SF715 A-B

Subject: Stalk Switches

On behalf of the entities listed below, Daimler Truck North America LLC (DTNA) is initiating Field Service Campaign SF715 to modify the affected vehicles.

PROBLEM: At initial key-on, certain stalk switches may experience power supply issues leading to various symptoms. Common indicators may include the engine/powertrain failing to start as well as unintentional activation of wipers and hazard lights.

Fig. 2, Examples of Vehicle Modifications Done at Plant

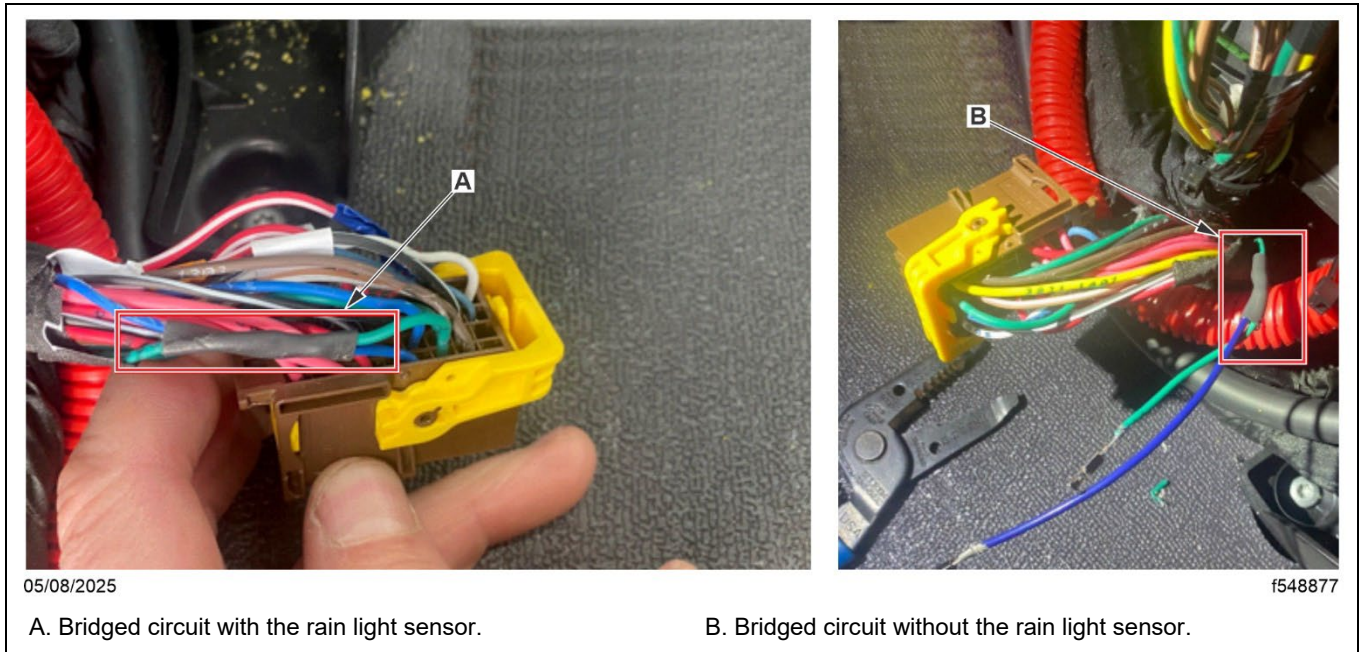
15. Inspect the wire harness and terminal cavities X5-6 and X5-7 for modifications that may have been done at the vehicle plant, as shown in **Fig. 2**, or based on the information in **Service Solution SS 3162-FTL** or **SS 775-WST**, as shown in **Fig. 3**. The modification is expected to be within 6 inches of the X5 harness connector.

16. Repair the harness.
 - For service solution-style modifications, cut the bridge (jumper) and turn the cut wires back on themselves. Use heat shrink lined with adhesive to seal and isolate the conductor.
 - For plant-style modifications, separate the bridge between the two conductors and repair the individual wires using DTNA approved methods.
17. Secure the harness repair with loom tape, as needed, to protect it from potential damage.
18. Install the X5 connector onto the sSAM.
19. Secure the individual wire bundles to the sSAM, as original.
20. Install the dash covers. For detailed instructions, see **Group 60: Cab** in the applicable workshop manual.
21. Install the ground cable connections at the batteries.
22. Clean a spot on the base label (Form WAR259), and attach a campaign completion sticker for SF715 (Form WAR261).

Fig. 2, Examples of Vehicle Modifications Done at Plant

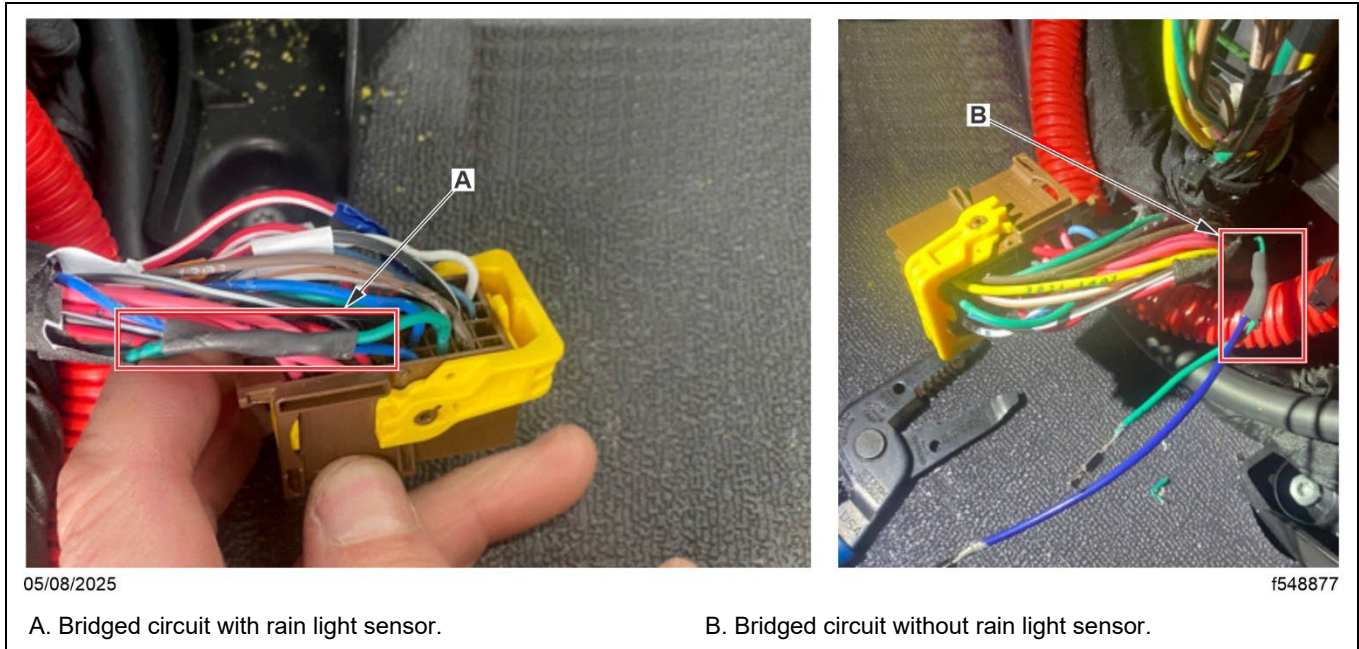
21. Inspect the wire harness and terminal cavities X5-6 and X5-7 for modifications that may have been done at the vehicle plant, as shown in **Fig. 2**, or based on the information in **Service Solution SS 3162-FTL** or **SS 775-WST**, as shown in **Fig. 3**. The modification is expected to be within 6 inches of the X5 harness connector.

22. Repair the harness.
 - For service solution-style modifications, cut the bridge (jumper) and turn the cut wires back on themselves. Use heat shrink lined with adhesive to seal and isolate the conductor.
 - For plant-style modifications, separate the bridge between the two conductors and repair the individual wires using DTNA approved methods.
23. Secure the harness repair with loom tape, as needed, to protect it from potential damage.
24. Install the X5 connector onto the sSAM.
25. Secure the individual wire bundles to the sSAM, as original.
26. Install the dash covers. For detailed instructions, see **Group 60: Cab** in the applicable workshop manual.
27. Install the ground cable connections at the batteries.
28. Clean a spot on the base label (Form WAR259), and attach a campaign completion sticker for SF715 (Form WAR261).
